Re: Railway (Metrolink - Estuary to Charlemont via Dublin Airport) Order [2022]
Metrolink. Estuary through Swords, Dublin Airport, Ballymun, Glasnevin and City Centre to
Charlemont, Co. Dublin

Re: Railway (Metrolink-Estuary to Charlemont via Dublin Airport) Order 2022

MetroLink Submission

Dartmouth Square West Submission

Figure 3: Railway Order Cross Section

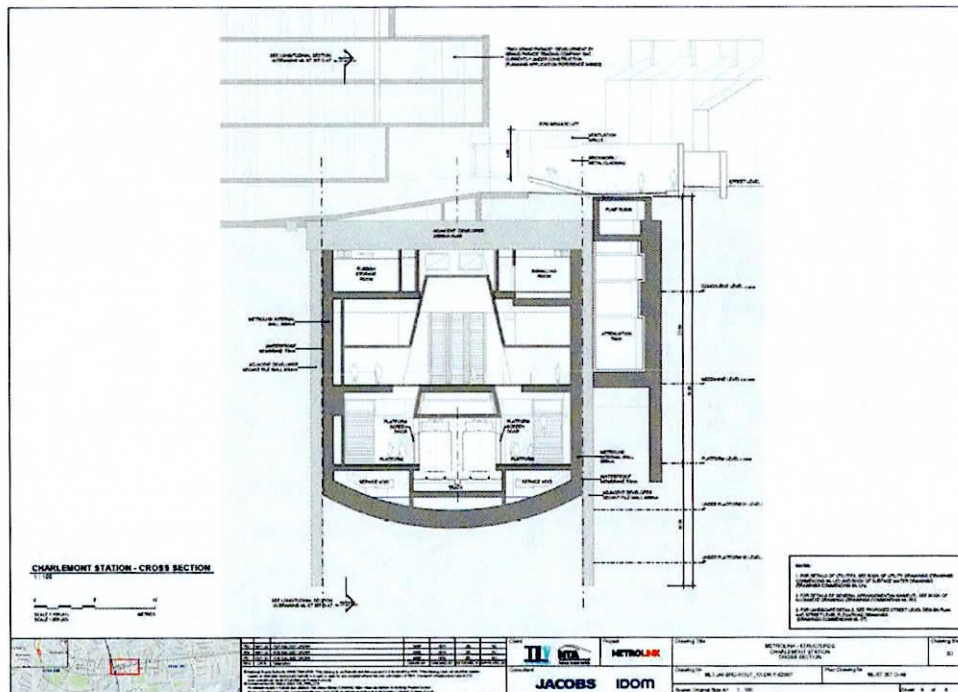
The very close relationship with the houses on Dartmouth Square West is illustrated by this section.

Figure 13: Settlement Contours (Dartmouth Square highlighted with red oval)

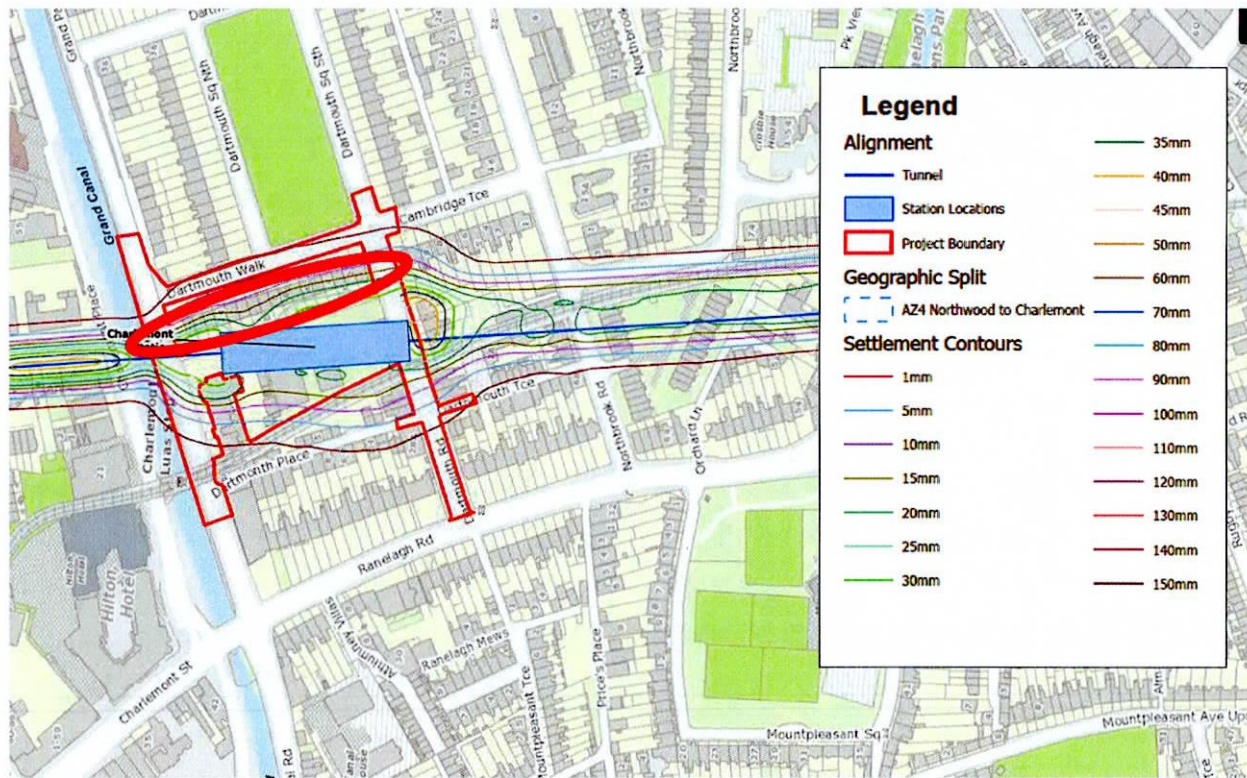
From a review of the EIAR and associated appendices, it is evident that a very limited assessment of settlement and subsidence has been carried out. It can be seen from the above diagram that the houses on Dartmouth Square West fall within the 10mm to 30mm settlement zone. This is defined as "slight" risk category. However, given that all bar one of the buildings covered by this submission are protected structures, they should be classed as damage category risk 3 (moderate). A phased system of assessment is proposed.

Appendix A5.17 provides an assessment of 'representative' buildings. It is unclear why these buildings were selected. There is no map illustrating the location of reference numbers/properties. The presentation of the information is opaque and unclear and does not facilitate a full and proper examination of the true impacts upon the houses on Dartmouth Square West. Again, this is a significant inadequacy in the EIAR.

The assessment effectively defers most of the assessment of subsidence and settlement to a further assessment. Such an assessment if undertaken after the railway order is issued, removes property owners' rights to review the actual impact of the development on their properties.

Figure 15: EIAR Construction Sequence

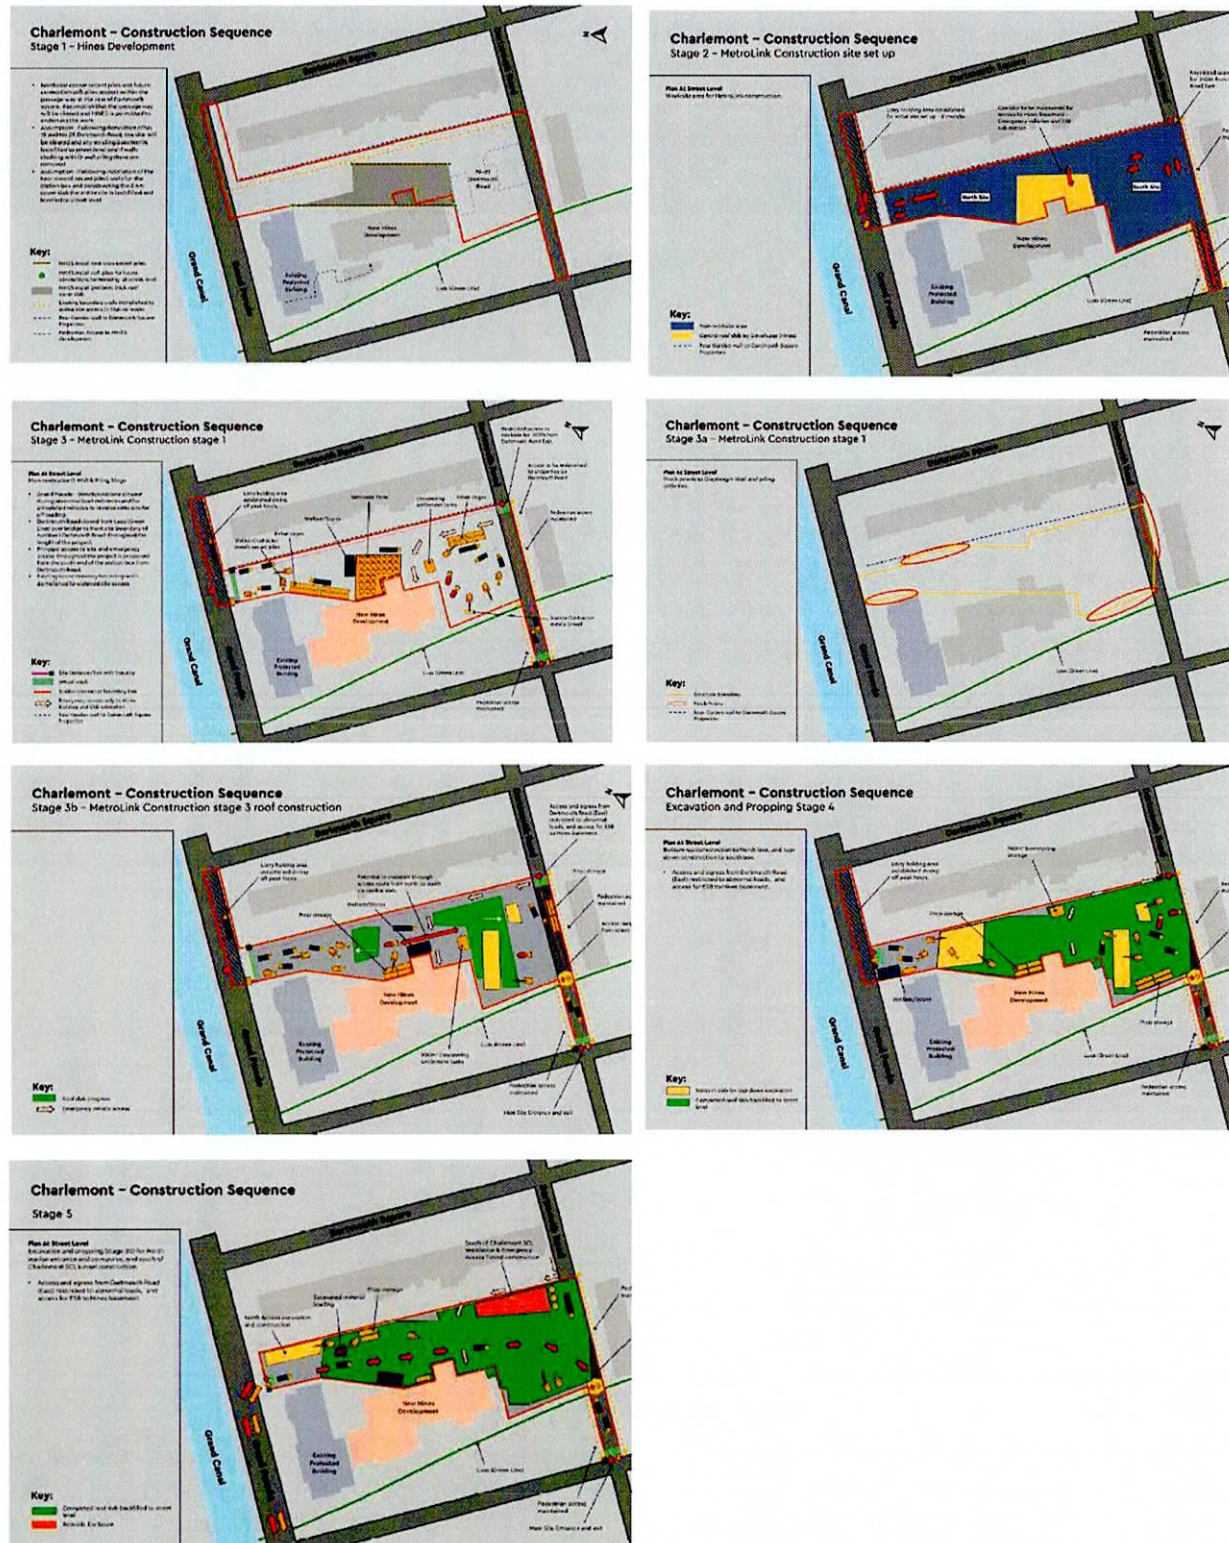
The above sequencing diagram illustrates how the project accepts that the station box constructed as part of the Two Grand Parade development (Hones Stage 1) is an integral and essential part of the project. Issues in relation to legality of this are considered in further detail in the General Submission prepared on behalf of Dartmouth and Charlemont Community Group.

Figure 16: Charlemont Traffic Management (Figure 7-58 of Appendix A9.5)

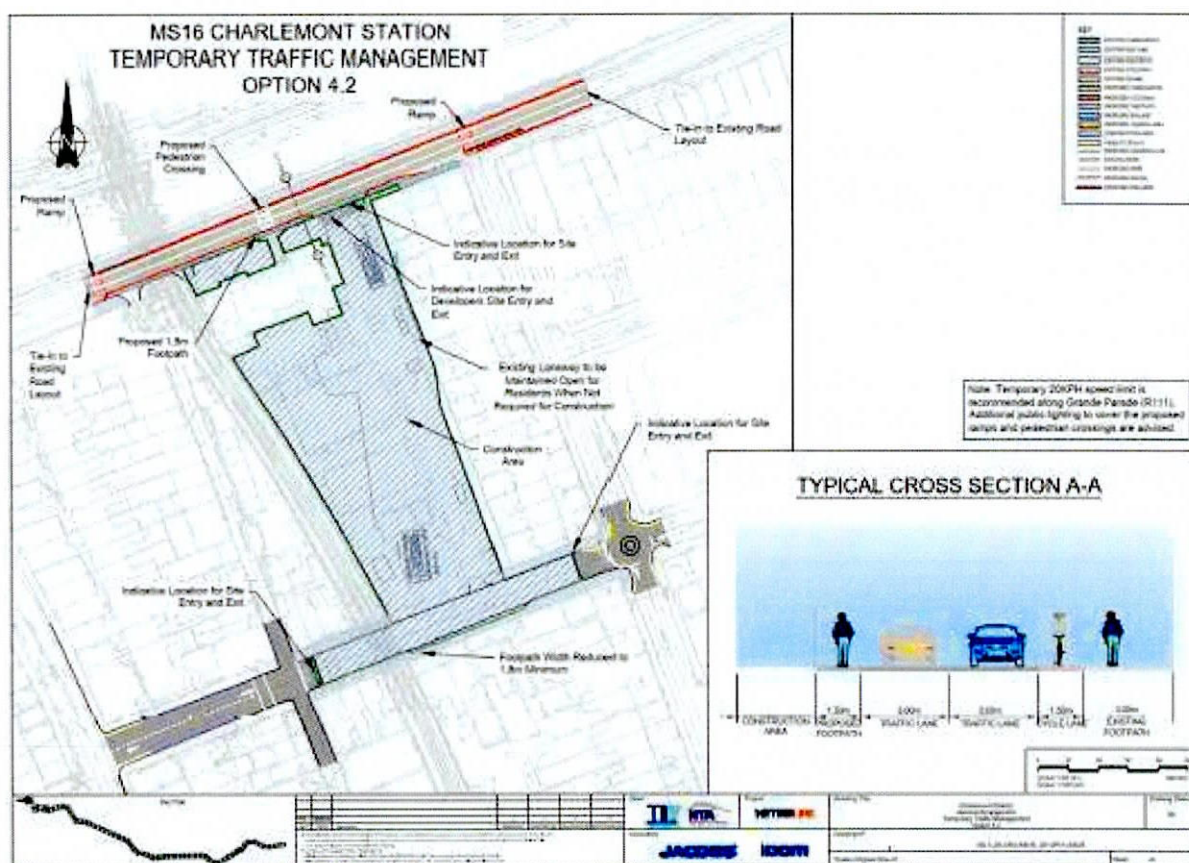
Appendix A9.5 suggests that the impact upon loading, parking and access is either slight or moderate. This in our opinion under-estimates the impact upon the residents of the properties listed in this submission. The construction sequence drawing illustrates that there would be a lorry holding area on Grand Parade during the stages 2-4 of the project. This has the potential to give rise to noise and disturbance, particularly for properties at the northern end of the Dartmouth Square West.

Figure 17: Ground Borne Noise during Operational Phase

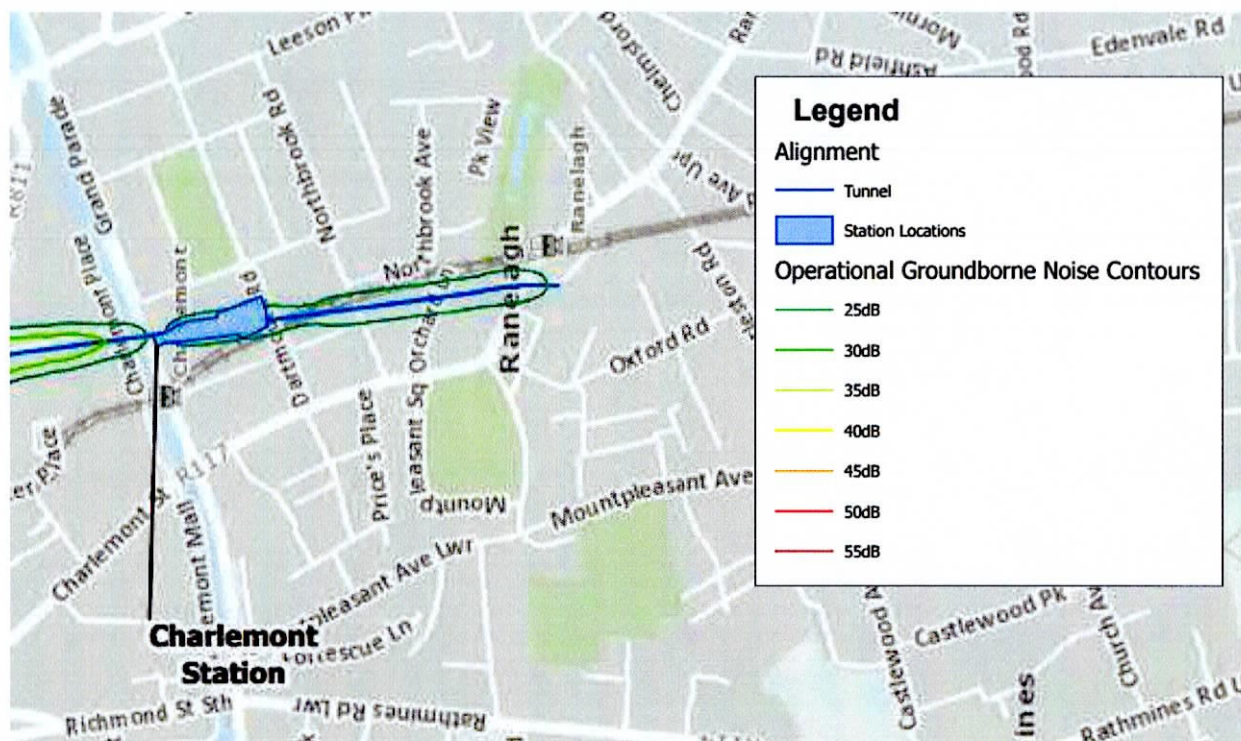
It is queried why only train rolling have been accounted for in the assessment of groundborne noise at operational stage. As demonstrated in the preceding section, there are other elements that should have been assessed, specifically ventilation. Ventilation, train rolling and the use of the PAVA system should be cumulatively assessed in accordance with the requirements of the EIA directive to provide a more accurate picture of operational noise levels.

Figure 18: Northern End Ventilation and Exhaust System (outline in red)

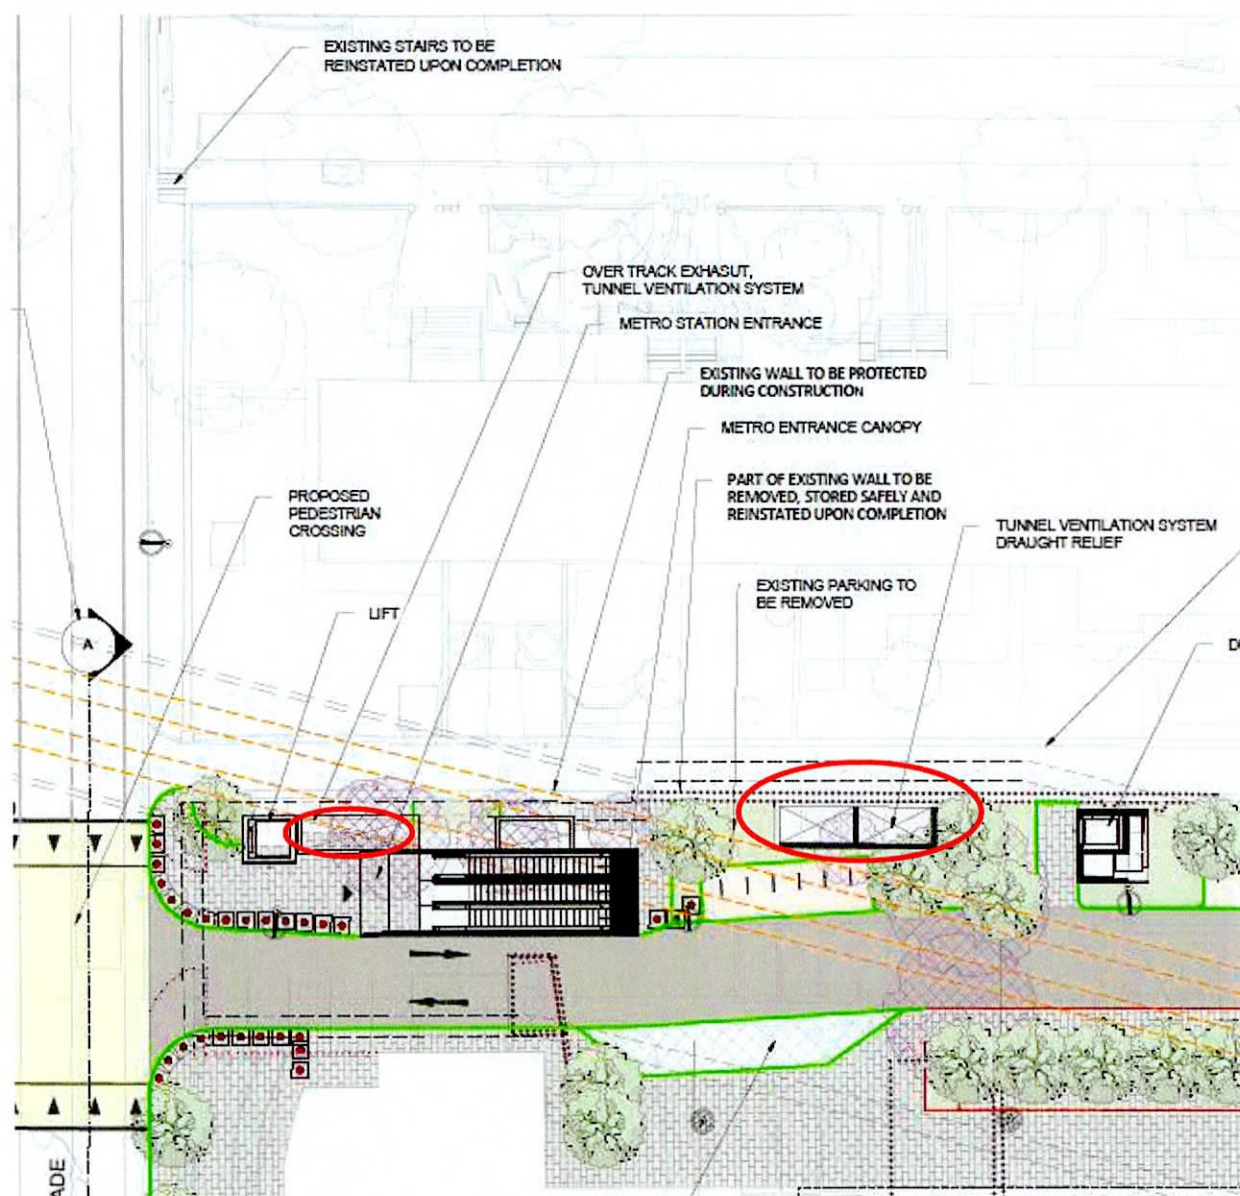
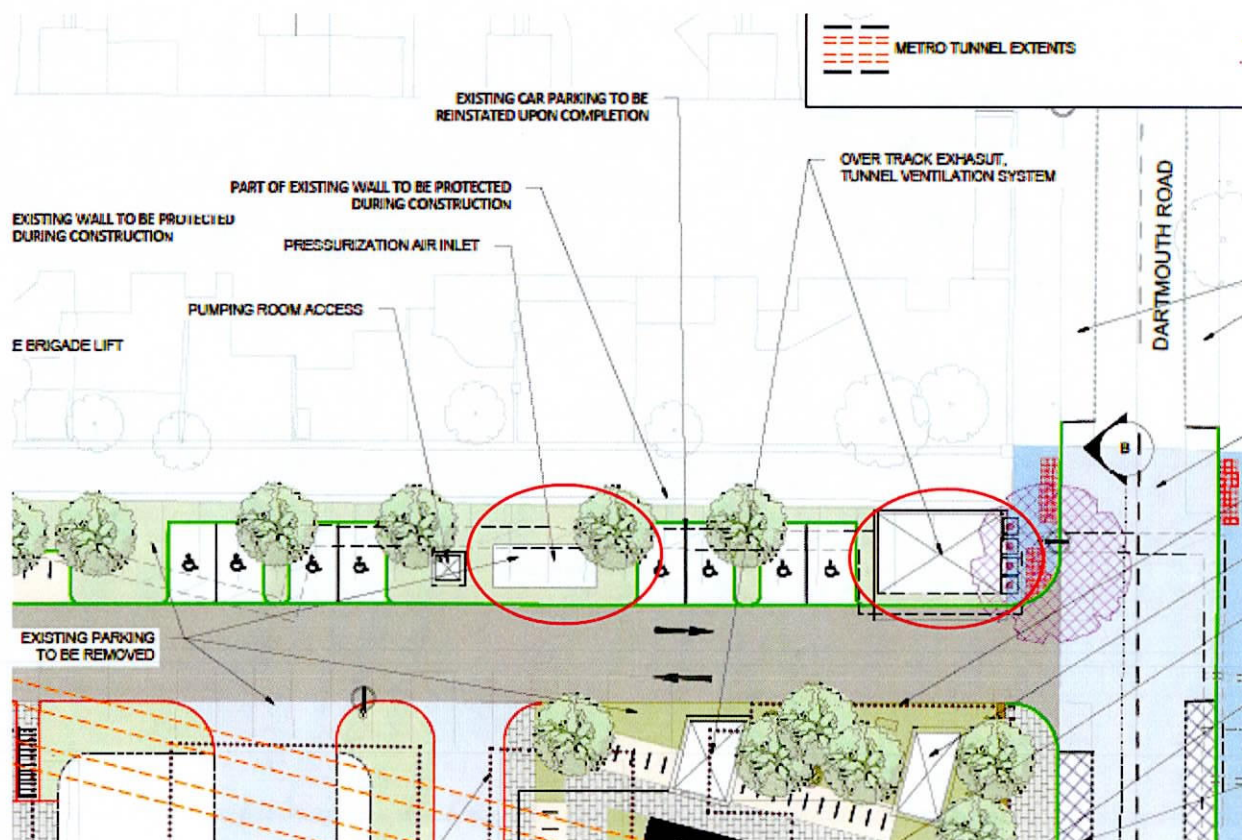
The proposed overtrack ventilation system and smoke exhaust gives rise to impacts that have not been properly assessed in terms of noise and air emissions. These systems are highlighted in the extract from drawing no. ML1-JAI-SRD-ROUT_XX-DR-Z-02090.

We would emphasise here that specific noise levels from ventilation systems have not been assessed as part of this EIAR but rather would *'be calculated as part of the further design development.'* Effectively the impacts upon the houses on Dartmouth Square West of the ventilation systems illustrated on the figure above have not been assessed.

Figure 20: Surface and Traffic Layout

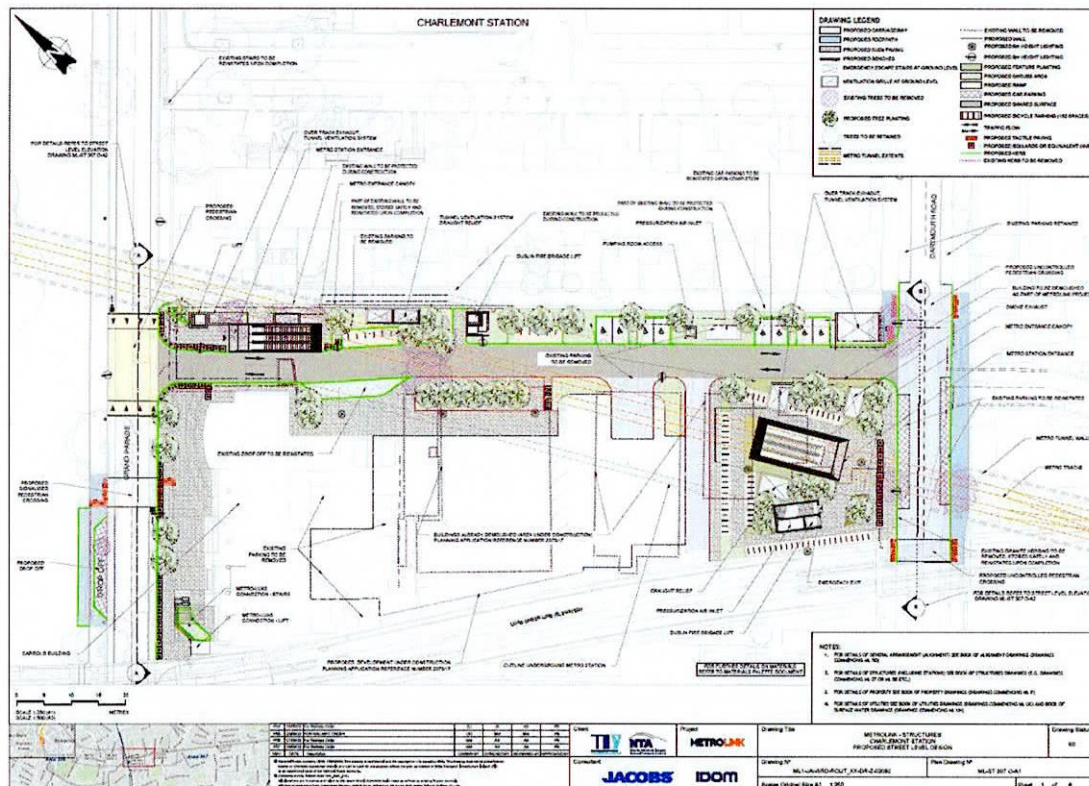
This is not however borne out by an examination of the submitted drawing no. ML1-JAI-SRD-ROUT_XX-DR-Z-02090.

The figure below illustrates the operational road and street layout around the station. General drop-off and pick up this major interchange have been further considered in the associated general submission. There is very limited drop-off or pick up facilities or proper interchange for taxi or future bus services. Given that the location of integration with bus services in this suburban location, it is likely that there will be a significant demand for such interchange facilities.

Figure 21: Pedestrian Heat Map from Traffic and Transport Assessment

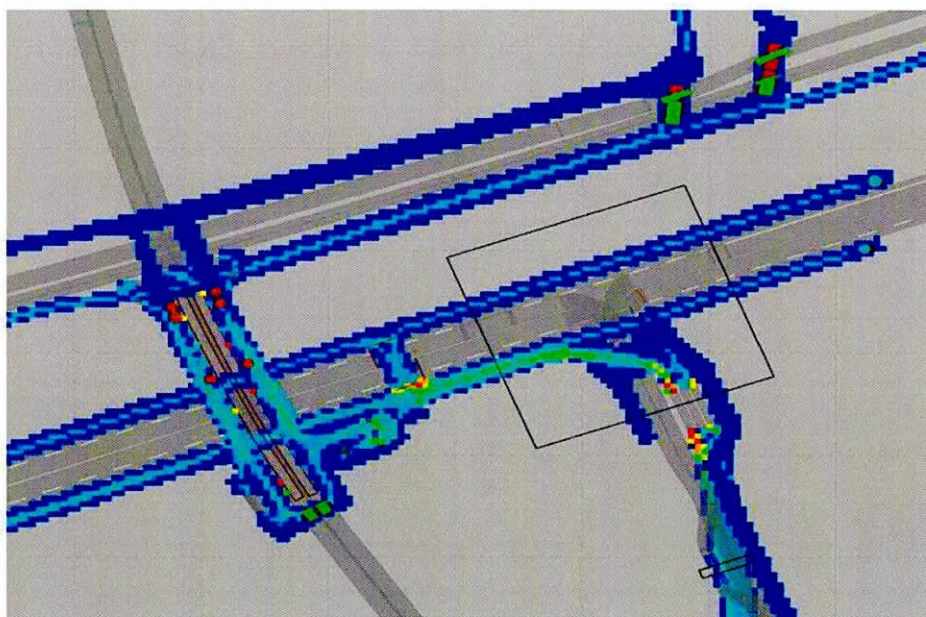
The figure below illustrates the level of pedestrian activity in and around the northern entrance to the station. This will give rise to a significant amount of activity in an around the detriment of residential amenities of those living in Dartmouth Square West.
